NL-15-0074

Joseph M. Farley Nuclear Plant  
Completion of Required Action by NRC Order EA-12-051  
Reliable Spent Fuel Pool Level Instrumentation

Enclosure 2

NRC Requests for Information

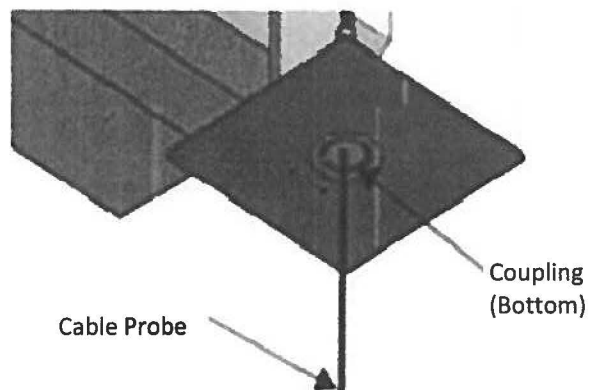
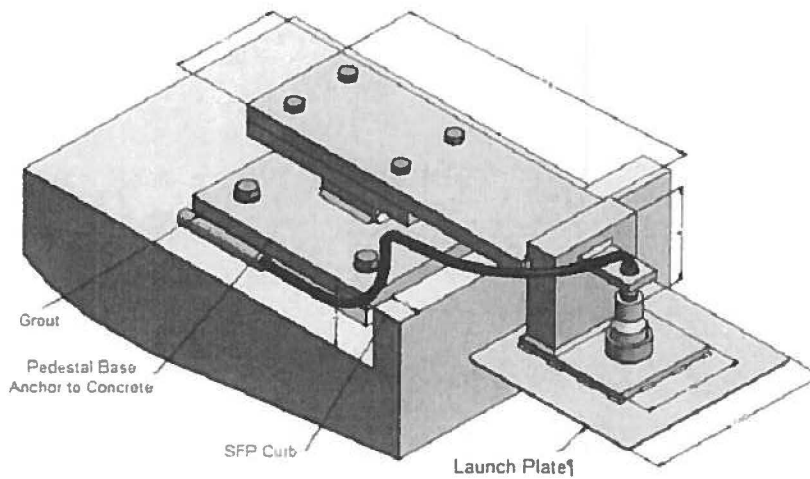
- b) A description of the manner in which the level sensor (and stilling well, if appropriate) will be attached to the refueling floor and/or other support structures for each planned point of attachment of the probe assembly. Indicate in a schematic the portions of the level sensor that will serve as points of attachment for mechanical/mounting or electrical connections.

- b) The mounting bracket is attached to the SFP concrete floor utilizing expansion-type concrete anchor bolts. The level sensor consists of a stranded stainless steel cable level probe that is threaded on the top end. The probe attaches (threads) into a coupling that is secured to the mounting bracket launch plate and extends down into the pool. The attachment to the signal cable is via a coaxial connection on the top side of the launch plate coupling.

The simplified drawing below shows a representation of the attachment of the probe and the sensor cable to the mounting bracket (launch plate), and mounting bracket attachment to the SFP structure. The Farley SFP does not have a raised concrete curb and as such, the mounting bracket does not utilize the curb for support.

Figure 1

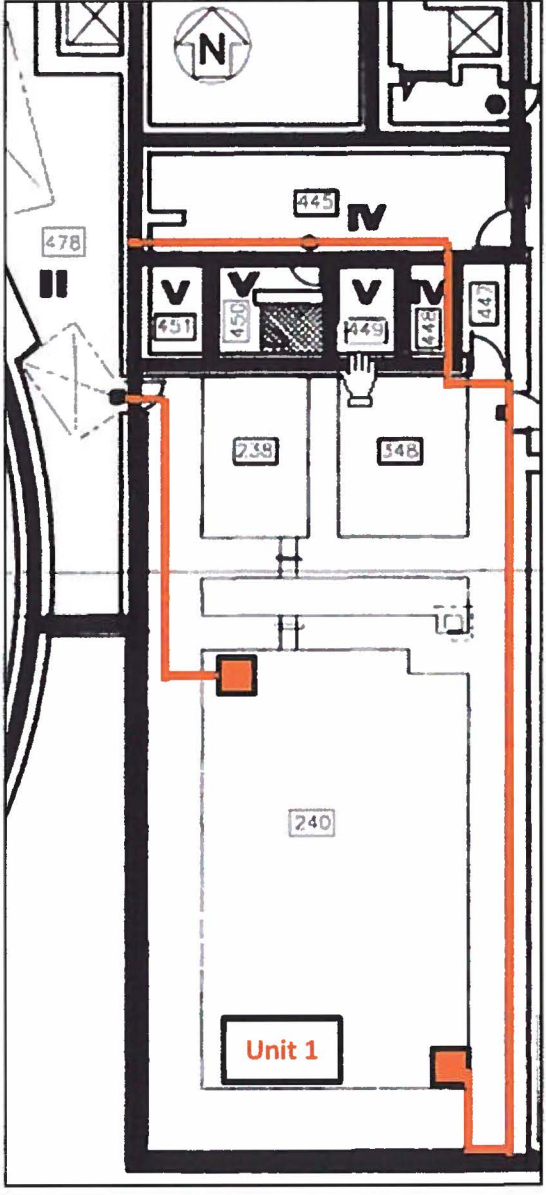
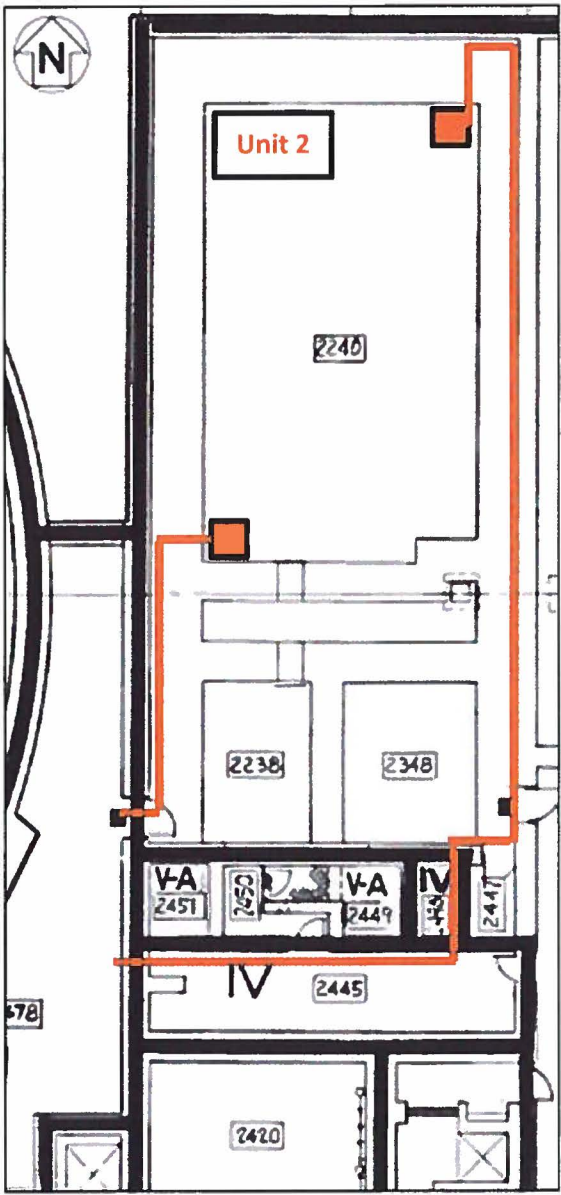
Please provide a clearly labeled sketch or marked-up plant drawing of the plan view of the SFP area, depicting the SFP inside dimensions, the planned locations/placement of the primary and back-up SFP level sensor, and the proposed routing of the cables that will extend from these sensors toward the location of the read-out/display device.

A plan view sketch of the SFP area is provided as Figure 1. The sketch depicts the SFP inside dimensions, locations/placement of the primary and alternate level sensors, and the routing of cables that extend toward the location of the electronics. Physical separation of the primary and alternate channels, to the extent practicable and comparable to the short side of the pool, is used to provide reasonable protection of the level indication function against missiles that may result from the damage to the structure over the SFP.

Figure 2

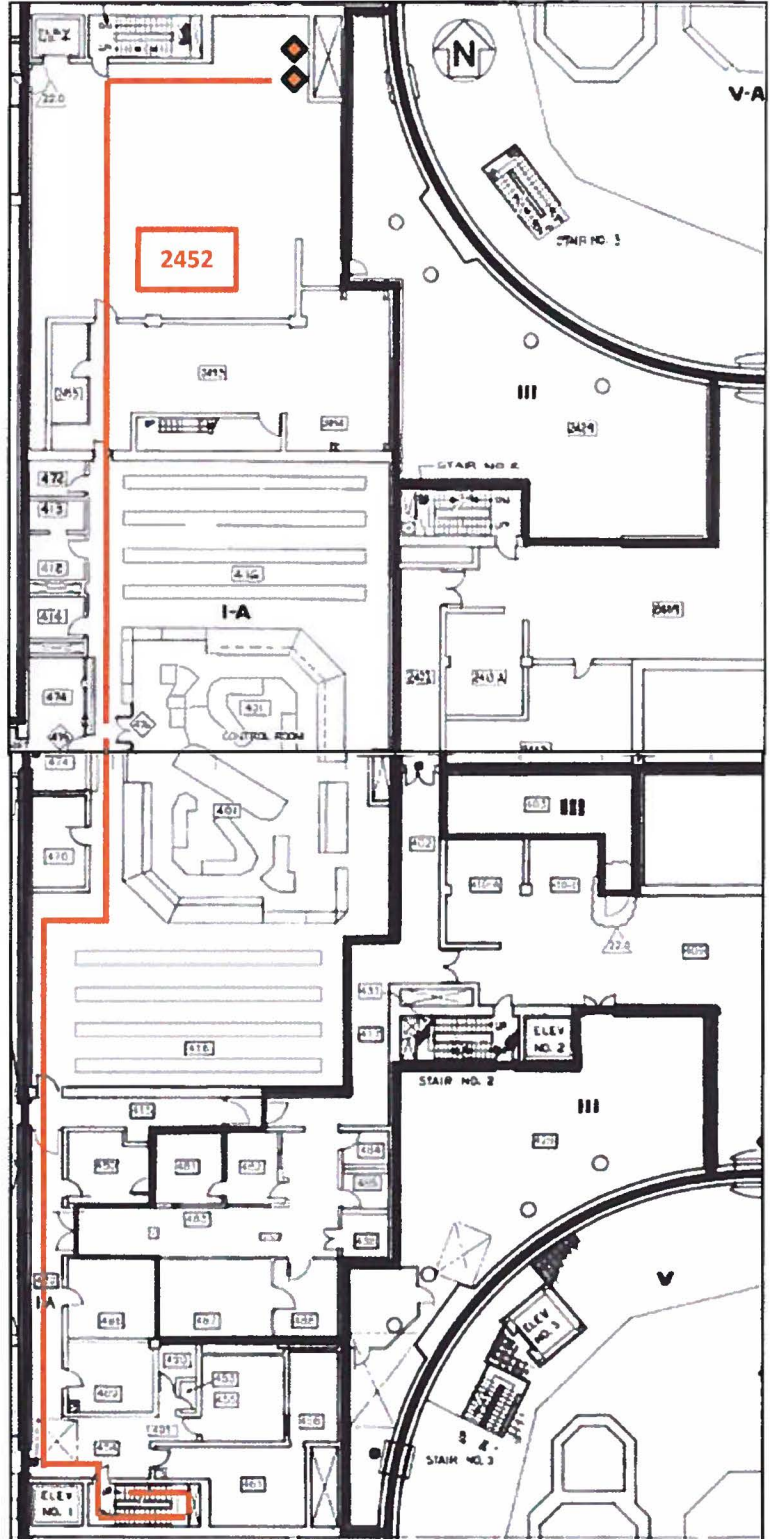
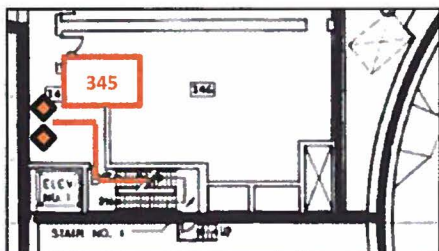
- a) The specific location for the primary and backup instrument channel displays.
- b) For any SFP level instrumentation displays located outside the main control room, please describe the evaluation used to validate that the display location can be accessed without unreasonable delay following a BDB event. Include the time available for personnel to access the display as credited in the evaluation, as well as the actual time (e.g., based on walk-throughs) that it will take for personnel to access the display. Additionally, please include a description of the radiological and environmental conditions on the paths personnel might take. Describe whether the display location remains habitable for radiological, heat and humidity, and other environmental conditions following a BDB event. Describe whether personnel are continuously stationed at the display or monitor the display periodically.

- a) See Figure 2 for SFPLIS equipment location sketches.

The location of the U1 and U2 Primary display panels is room 2452 on EL 155' of the Aux Building. The location of the U1 and U2 Alternate display panels is room 345 on EL 139' of the Aux Building.

The selected location of the U1 and U2 Primary display panels in room 2452 on EL 155' of the Aux Building is approximately 180 feet from the West exit of the Control Room. The selected location of the U1 and U2 Alternate display panels in room 345 on EL 139' of the Aux Building is approximately 220 feet from the West exit of the Control Room. Using a conservative walking pace of 1 mph, Primary & Alternate display locations would each require less than 10 minutes to access the display location, perform local function and return to the Control Room. With the displays located outside the Radiation Controlled Area, the substantial structures between the SFP and the pathway to the display, combined with the short transient duration, personnel traveling the pathways

shown on Figure 2 will not require heroic means with the SFP at Level 3 or above. The display location remains habitable considering the: (1) minimal time required to periodically access the displays, (2) distance from the SFP and substantial structures, and (3) the lack of heat producing equipment within the room during accident conditions. Accordingly, both the Primary and Alternate SFPLI panel locations allow prompt, non-heroic access to the displays from the Control Room necessary to allow periodic monitoring of the SFP level.
